APPLICATION NO.	FILING DATE	FIRST NAMED INVENTOR	ATTORNEY DOCKET NO.	CONFIRMATION NO.
10/820,186	04/07/2004	Thomas R. Marsh	9066-23DV	7421

Office Action Summary	Application No. 10/820,186	Applicant(s) MARSH ET AL.	
	Examiner Carlos Lugo	Art Unit 3676

DETAILED ACTION

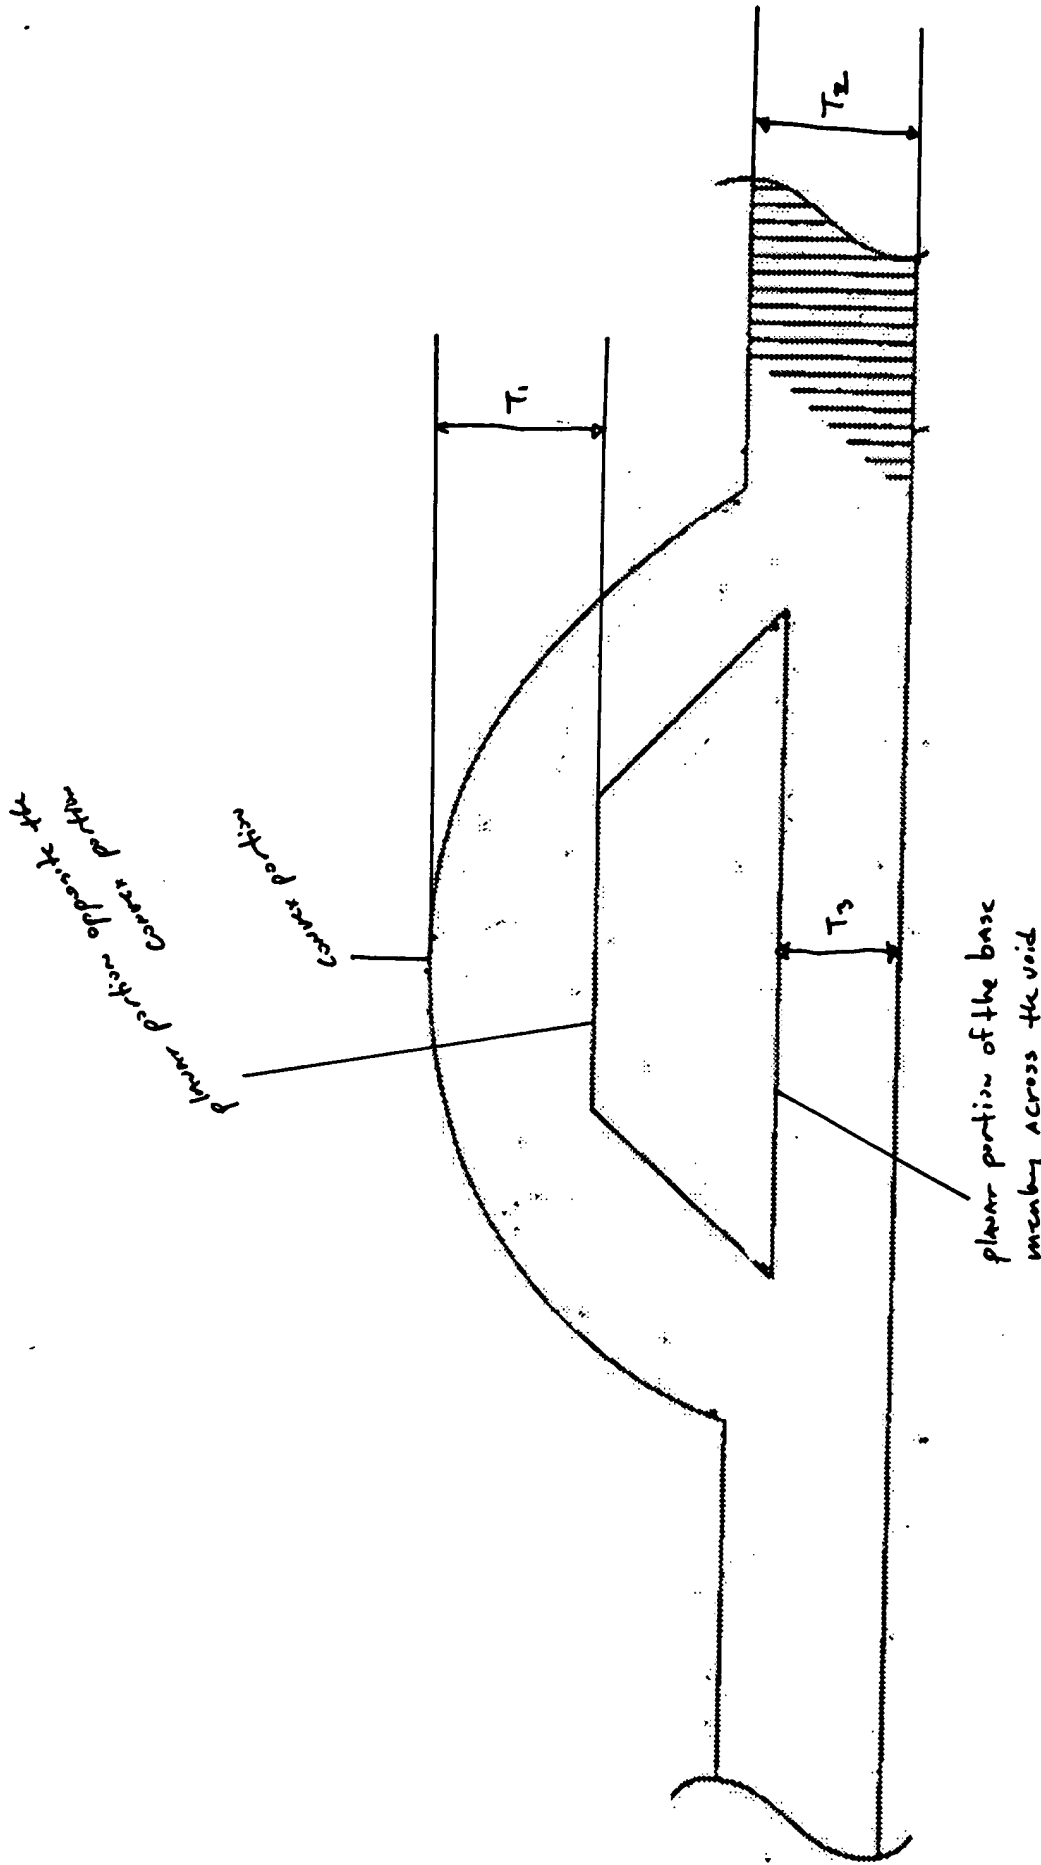
Claim 5 recites that the projection has a convex portion extending outwardly from the second face of the base member and a planar portion opposite the convex portion, and that the planar portion of the projection has a thickness that is less than the thickness of the base member.

However, as seen in Figure 1, the thickness between the planar and the convex portion of the projection is the same as the thickness of the base member. The only different in thickness is between the thickness of the base member and the planar portion of the base member across the void or the thickness between the planar and the convex portion of the projection and the planar portion of the base member across the void (see attachment #1).

T_1 = Thickness of the portion between the plasma and the covers portion of the projection

T_2 = thickness of the base membrane

T_3 = thickness of the plasma portion of the base membrane across the void

$$T_1 \approx T_2$$

$$T_1 > T_3$$

$$T_2 > T_3$$

Therefore, in order to continue with the examination, the limitation will be examined as the planar portion of the base member across the void has a thickness that is less than the thickness of the base member. Appropriate correction and/or explanation is required.
